DRAFT POGONIP MASTER PLAN ENVIRONMENTAL IMPACT REPORT

Volume Two

- Responses to Comments
- Revisions to Draft EIR
- Mitigation Monitoring Program

submitted to the:
CITY OF SANTA CRUZ
DEPARTMENT OF PARKS AND RECREATION

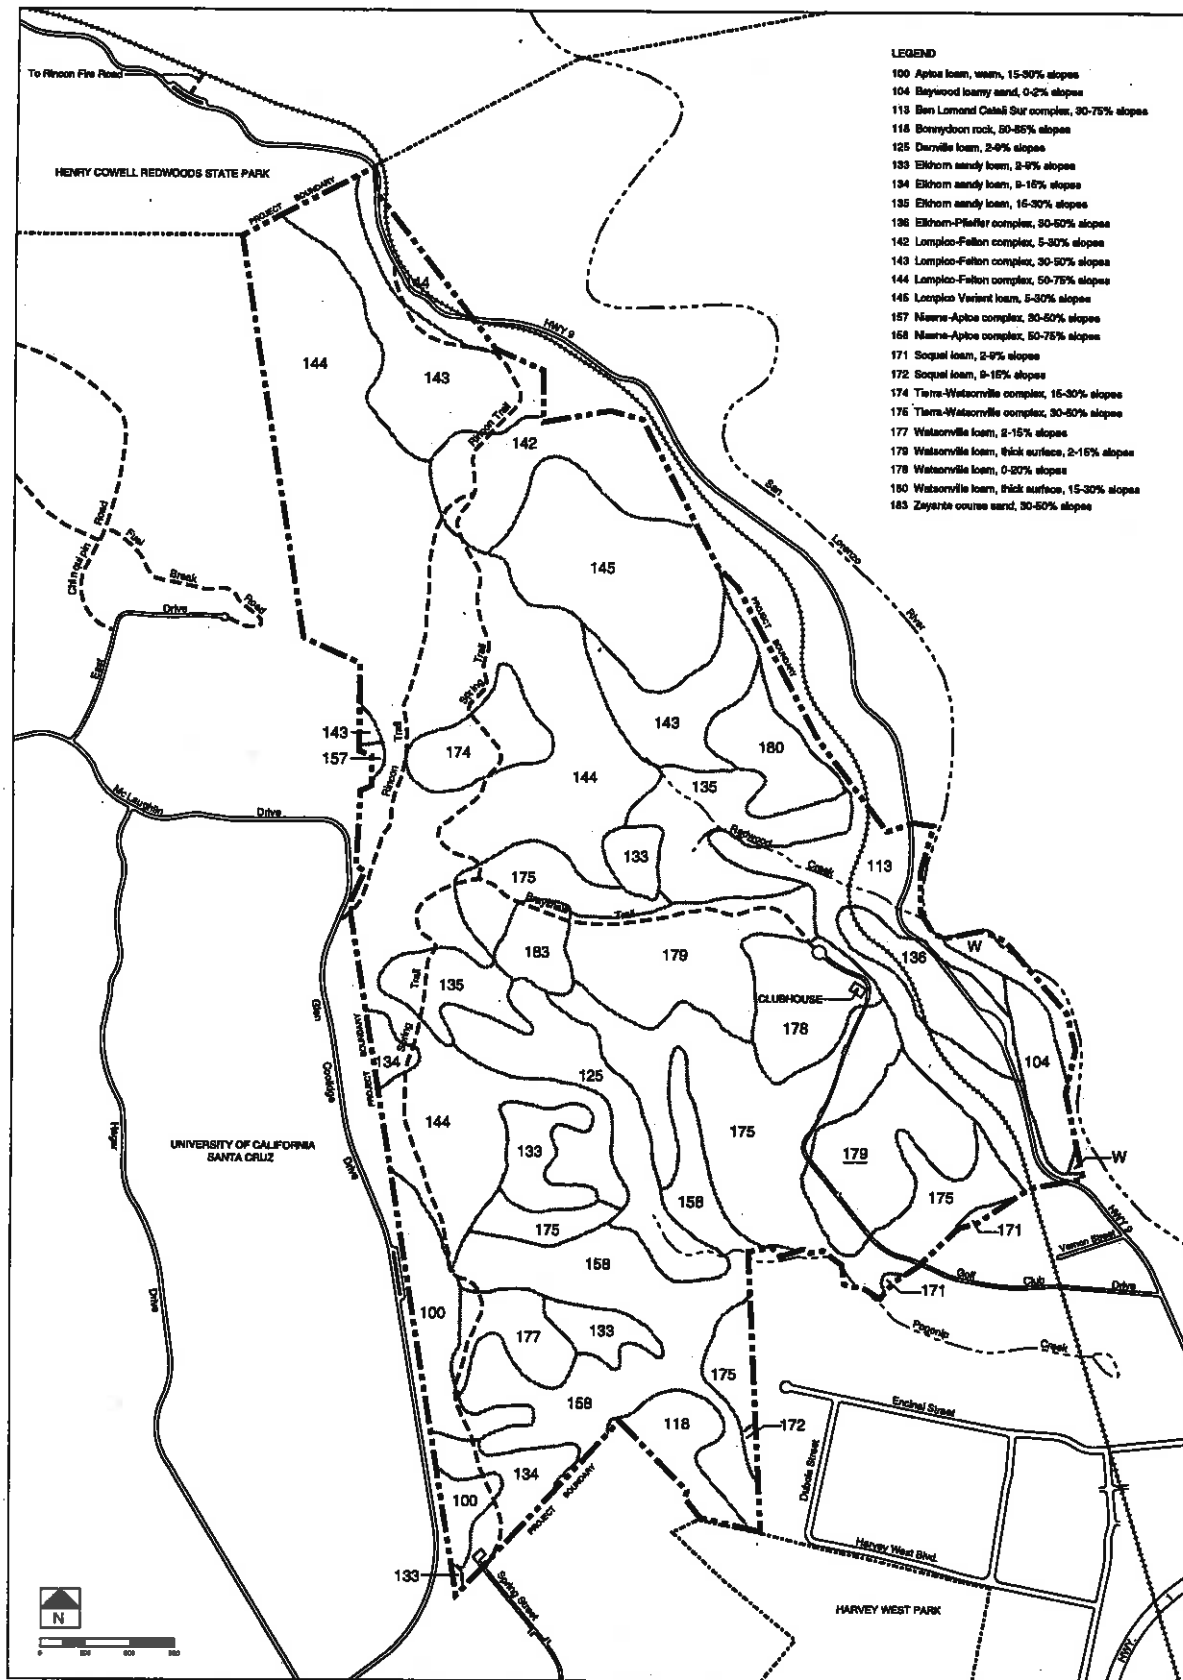
- IV.C-6 Map features on Figure IV.C-2 have also been modified to reflect a change to, as shown on the following page.

Figure V-1
Reduced Lower Meadow Use Site Plan

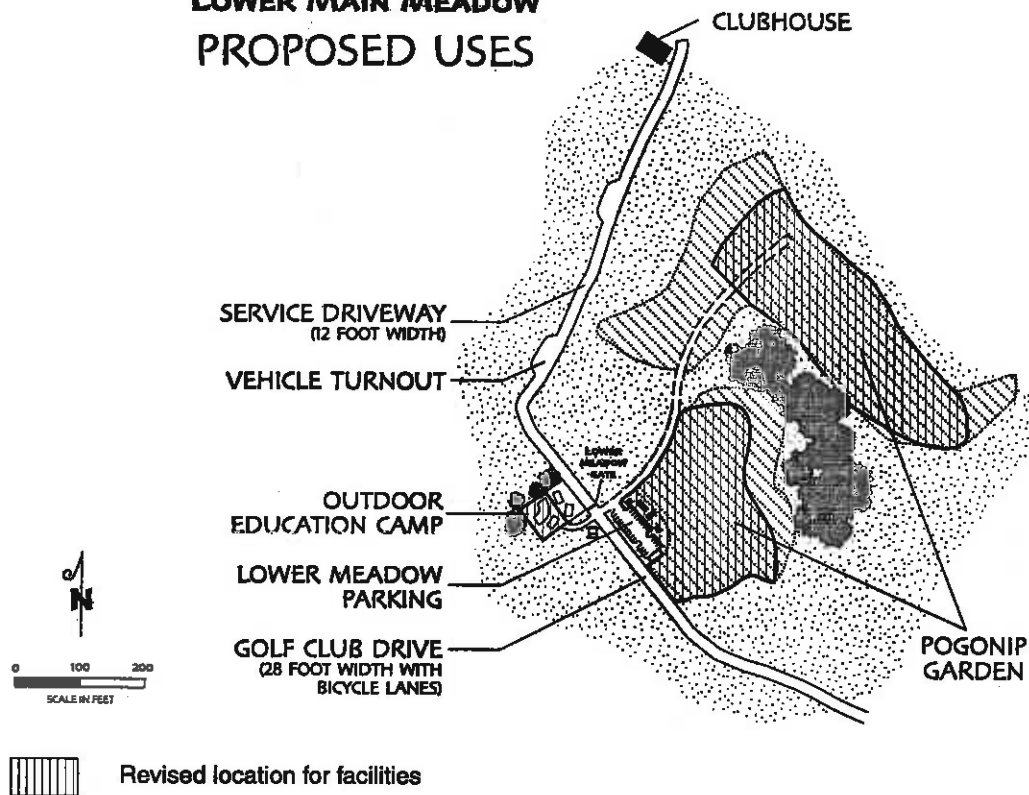
- C18. As stated on page V-5, last paragraph, the Lower Meadow Parking area would be reduced to 15 spaces from the project's 30 spaces and these would be located along Golf Club Drive. The Reduced Garden Alternative has also been revised to include a 15-car parking lot rather than the project's 30 spaces. Figure V-1 shows the proposed site for the reduced parking area under both alternatives.

The Lower Meadow parking lot would be ~~unchanged~~ reduced and would provide a maximum of ~~30~~ 15 spaces for park visitors and Pogonip Garden Project staff (refer to Figure V-1). Shareholder pickups would occur off-site or would be carefully scheduled to ensure adequate parking spaces are available. The number of parking spaces for Garden employees would be reduced to five spaces."

"...prairie habitat and the white tailed kite. These spaces would be located in the area along Golf Club Drive. shown on Figure V-1."

Figure VI-1(a)
Eastern Access: Route Alternatives

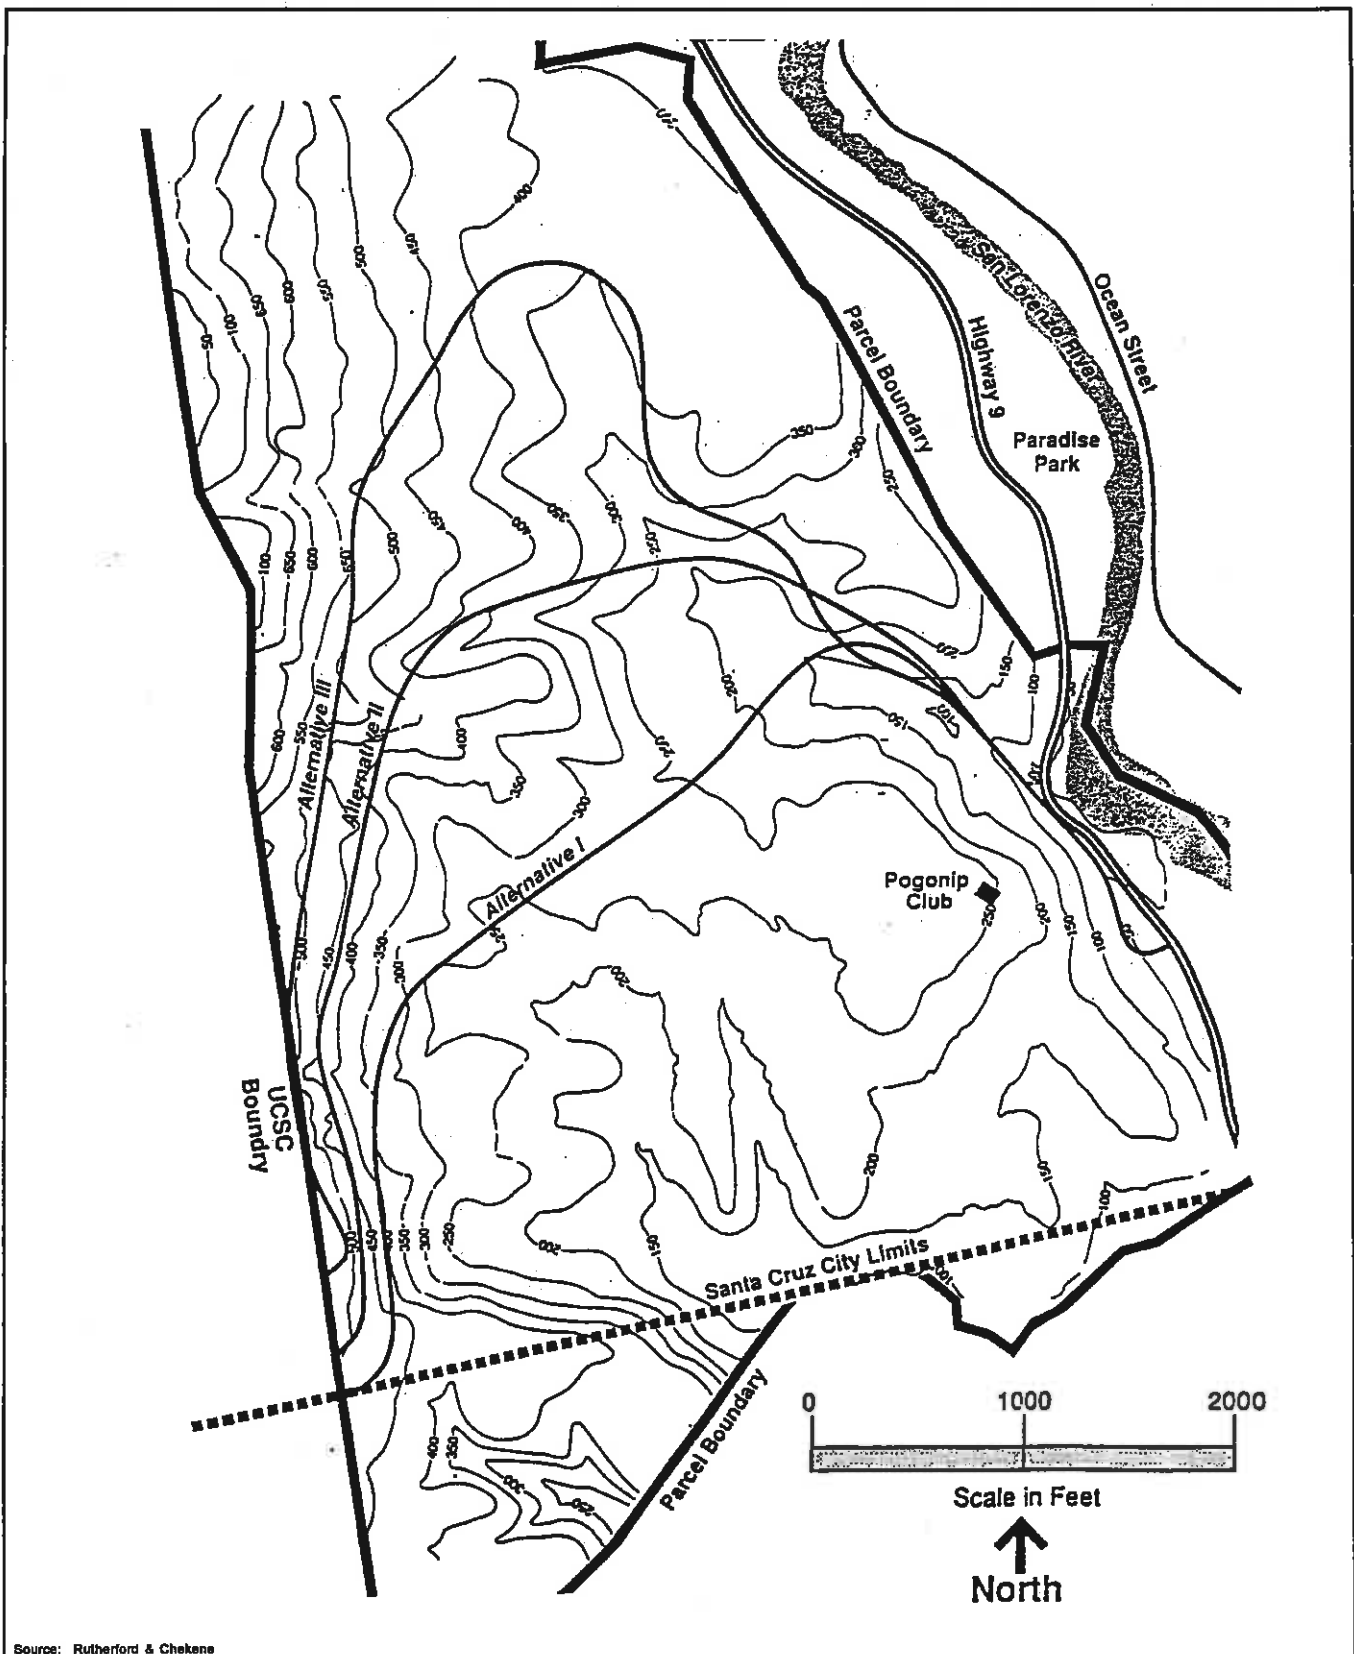
- B3.** The relocatable easement for an eastern access road through Pogonip is addressed with new text in the Land Use, Traffic and Circulation and Cumulative Impacts sections of the DEIR. A new figure, Figure VI-1(a) is also added to the DEIR and shown on the following page. The eastern access road has not been included in the DEIR planning history section because this section is intended to provide background information for the *Pogonip Master Plan*. The eastern access road is considered a separate project from the proposed rises in the Master Plan.

- VI-5 Figure VI-1(a) is added to the DEIR and shown on the following page. The following text is added after the first full paragraph on page VI-5 of the DEIR:

"The uses as proposed in the Draft Pogonip Master Plan would not preclude development of an eastern access road across Pogonip. Because no resolution regarding the eastern access road has been passed, this potential development is not evaluated in the discussion of cumulative impacts."
